PIC16(L)F1933 Silicon Errata and Data Sheet Clarification

The PIC16(L)F1933 family devices that you have received conform functionally to the current Device Data Sheet (DS41575C), except for the anomalies described in this document.

The silicon issues discussed in the following pages are for silicon revisions with the Device and Revision IDs listed in [Table 1](#). The silicon issues are summarized in [Table 2](#).

FIGURE 1: INSTRUCTION CYCLE DELAY CALCULATION EXAMPLE

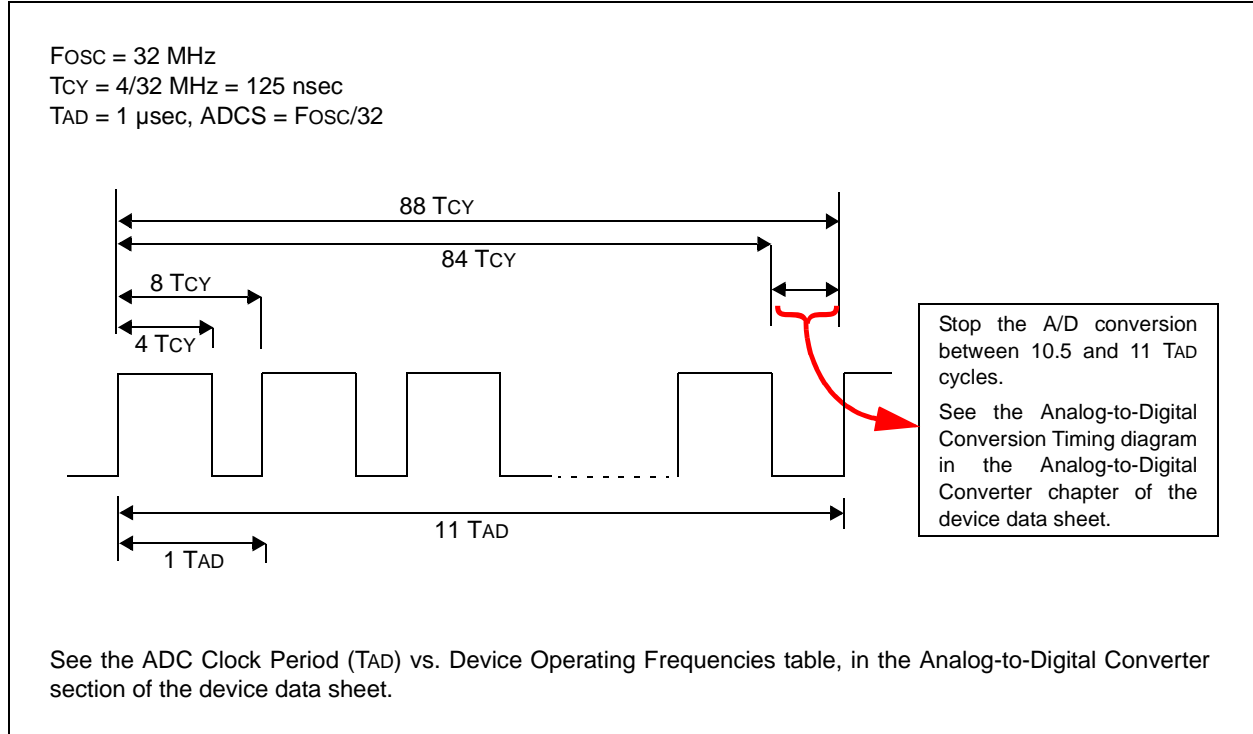
An ADC conversion may not complete under these conditions:

1. When FOSC is greater than 8 MHz and it is the clock source used for the ADC converter.
2. The ADC is operating from its dedicated internal FRC oscillator and the device is not in Sleep mode (any FOSC frequency).

When this occurs, the ADC Interrupt Flag (ADIF) does not get set, the GO/DONE bit does not get cleared, and the conversion result does not get loaded into the ADRESH and ADRESL result registers.

Method 3: This method is provided if the application cannot use Sleep mode and requires continuous operation at frequencies above 8 MHz. This method requires early termination of an ADC conversion. Provide a fixed time delay in software to stop the A-to-D conversion manually, after all 10 bits are converted, but before the conversion would complete automatically. The conversion is stopped by clearing the GO/DONE bit in software. The GO/DONE bit must be cleared during the last ½ TAD cycle, before the conversion would have completed automatically. Refer to [Figure 1](#) for details.

In [Figure 1](#), 88 instruction cycles (Tcy) will be required to complete the full conversion. Each TAD cycle consists of 8 Tcy periods. A fixed delay is provided to stop the A/D conversion after 86 instruction cycles and terminate the conversion at the correct time as shown in the figure above.

Note: The exact delay time will depend on the TAD divisor (ADCS) selection. The Tcy counts shown in the timing diagram above apply to this example only. Refer to [Table 4](#) for the required delay counts for other configurations.

FIGURE 5-4: CERAMIC RESONATOR OPERATION (XT OR HS MODE)

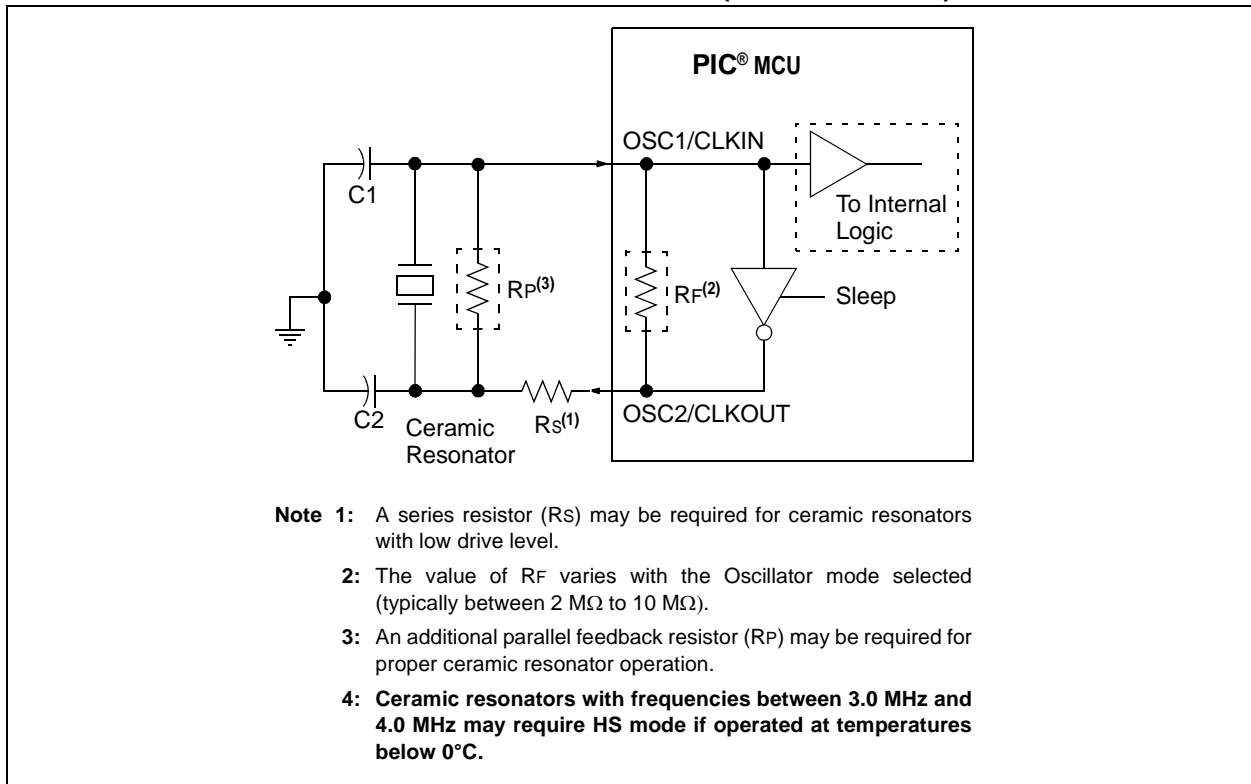
In [Figure 5-4](#), note 4 is added as following:
